10 April 2025

Re: 8, 12 and 16 Jamieson Street, Bowen Hills, **DEV2024/1590** on behalf of **New Urban Villages Pty Ltd.**

Figure 3 – Illustration that either property connection location results the same outcome

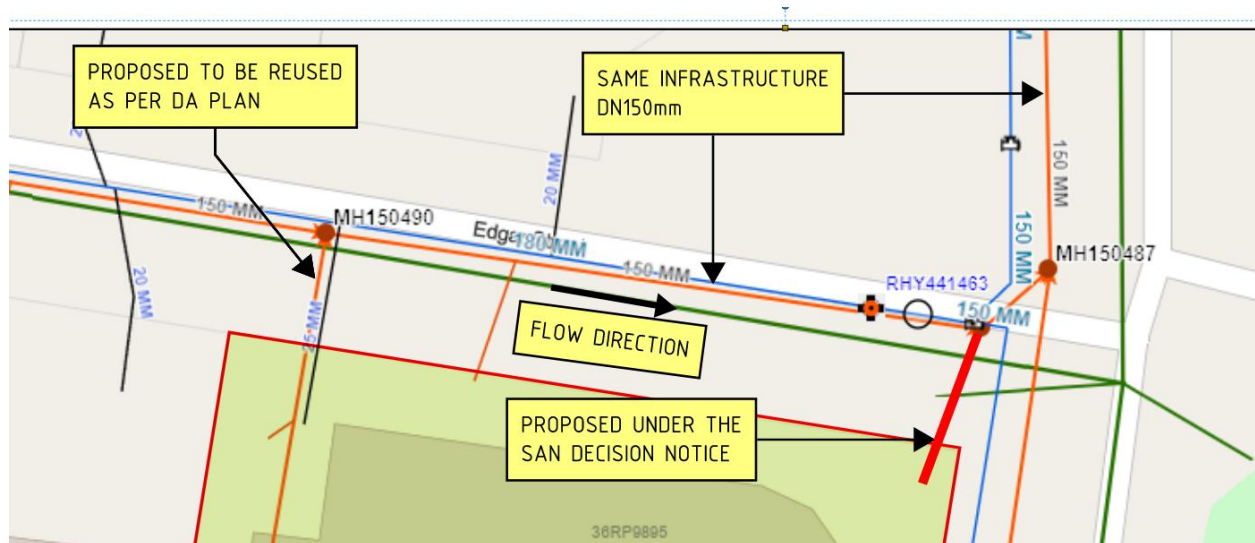
The proposed connection point accepted by UU in the submitted SAN is not in accordance with the design concept submitted to EDQ. EDQ can impose a condition requiring the applicant to provide amended plans that reflect the Energex SANs or alternatively, submit an updated SAN in which UU confirms their acceptance of the amended design.

We acknowledge the discrepancy between the submitted SAN and the design concept lodged with EDQ. However, we strongly believe that neither amendments to the plans nor the submission of an updated SAN is required. Reusing the sewer property connection as proposed in the DA plans or aligning with the SAN markups results in the same infrastructure configuration. Both the SAN and the DA plan connection utilize the same infrastructure, connecting directly with the same pipe main DN150mm. Consequently, any additional assessments or submissions would be redundant and offer no added benefit or outcome concerning infrastructure performance or compliance.
